SERVICE BULLETIN

No. 210

Piper Aircraft Corporation

SUBJECT: Replacement or Modification of Muffler Shrouds

A

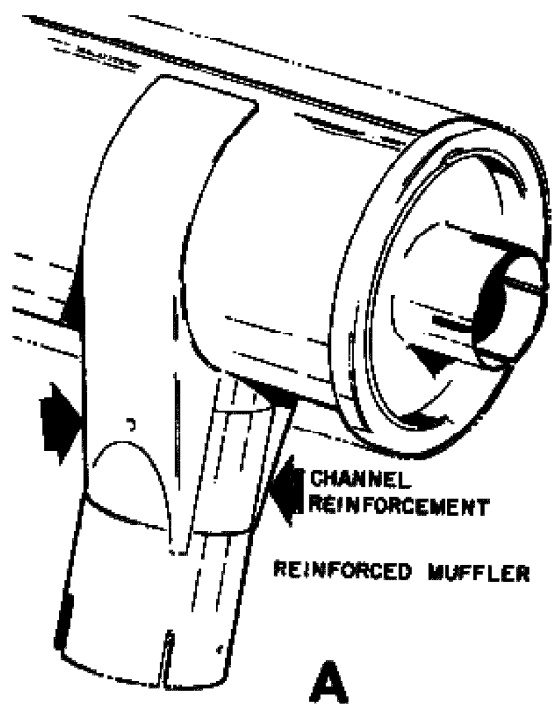
Comanche mufflers have been manufactured incorporating two different styles of tailpipe reinforcement brackets. However, this Service Bulletin requires modification of one style only; those with the channel-shaped reinforcement. See Sketch "A" for further identification. Both styles of muffler have been sold as service replacements. It will therefore be necessary to inspect aircraft, Serial Nos. 24-1 to 24-2587 inclusive if the original muffler has been replaced, to determine if compliance with this Bulletin is required.

CHANNEL
REINFORCEMENT

REINFORCED MUFFLER

B

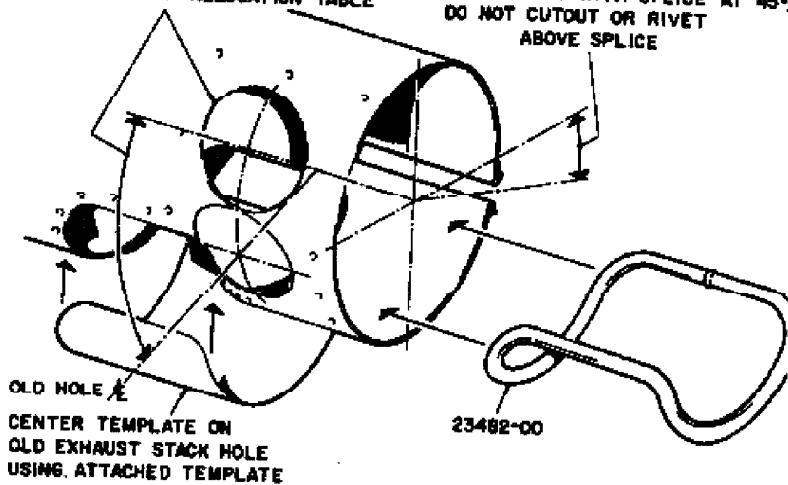
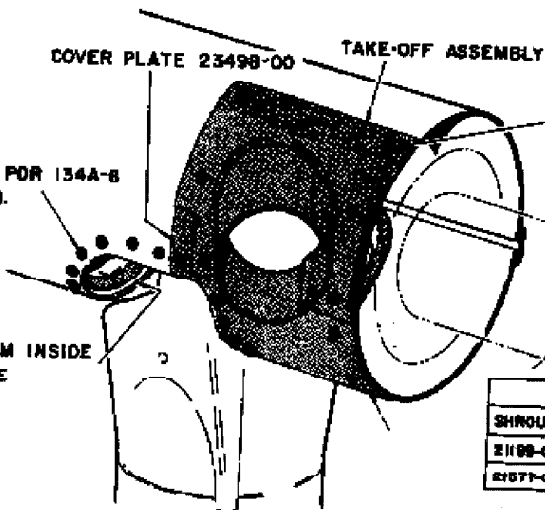
8. Cut the new opening in the aluminum shroud, taking care not to cut past the splice. (See Note Sketch "B.")
 9. Install the muffler housing reinforcement tube, part number 23482-00, on the inside of the aluminum heater shroud. (See Sketch "B.")

10. Relocate the cold air inlet take-off assembly as shown on the take-off relocation table and install cover plate, part number 23498-00, over old hole. Trim cover plate as required. (See Sketch "B.")

ON SHROUDS WITH SPLICE AT 45°
DO NOT CUTOUT OR RIVET
ABOVE SPLICE

OLD HOLE
CENTER TEMPLATE ON
OLD EXHAUST STACK HOLE
USING ATTACHED TEMPLATE

CUTOUT APPROX. $\frac{1}{8}$ " FROM INSIDE
OF REINF. TUBE

COVER PLATE 23498-00 TAKE-OFF ASSEMBLY

RIVET AN426A3-4
11 REQ.

RIVET PDR 134A-B
20 REQ.
